APPLICATION NO.	FILING DATE	FIRST NAMED INVENTOR	ATTORNEY DOCKET NO.	CONFIRMATION NO.
10/058,643	01/28/2002	Anthony Nocella III	984	3850

Office Action Summary	Application No.	Applicant(s)	
	10/058,643	NOCELLA, ANTHONY	
	Examiner	Art Unit	
	Winnie Yip	3637

DETAILED ACTION

Fig. 1

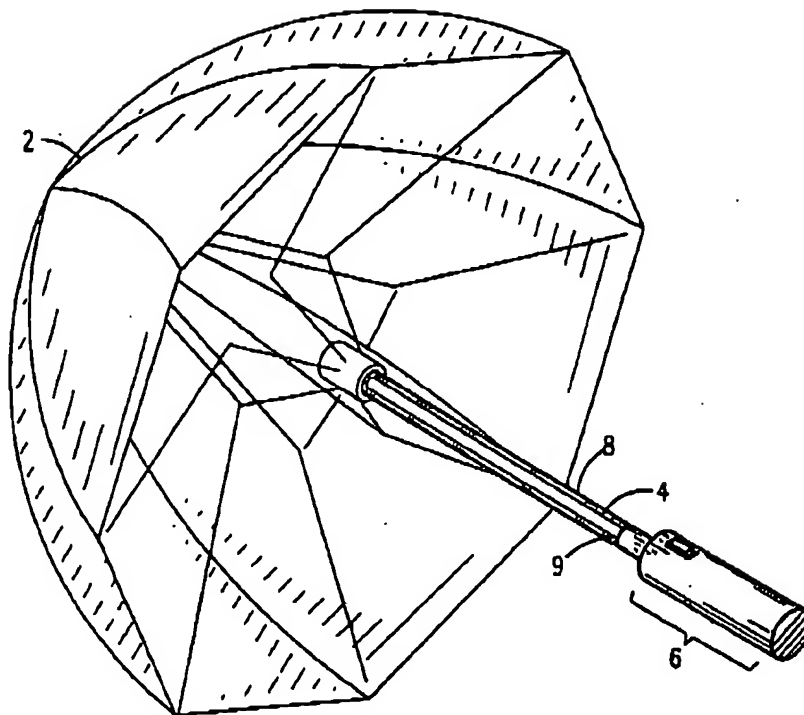
disapproved
mg
8/25/05

Fig. 2

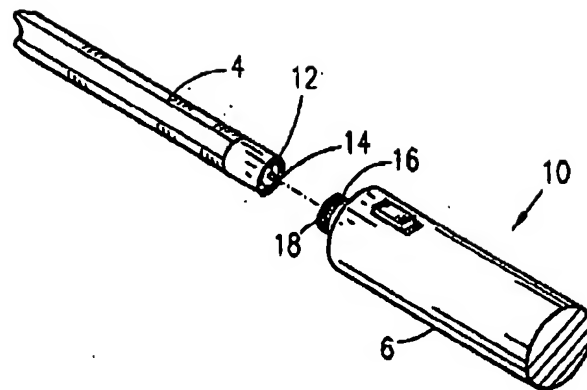
I. The drawings correction filed June 21, 2005 are disapproved because they include a new matter which is not originally filed.. The new subject matter is: the proposed drawing Fig. 2 changes the batteries (12) being located on the lower end of the shaft and the end cap at the upper end of the handle section which are not supported by either the specification and the drawings as originally filed. According to the disclosure, page 5, lines 11-17, and the drawing Fig. 2 as originally filed, the batteries 12 “are stored within a cavity inside of the handle section (10), “a series of threads 14 are formed along the lower rim of the handle, and “a screw cap 16 with matching, receiving the threads 18 mate to the threads 14 to removably contain the batteries 12”. The proposed drawing Fig. 2 provides a new position of the barriers 12 and the cap 14 as different then Fig. 2 as originally filed. New matter must be cancelled.

disapproved
w/ 8/25/05
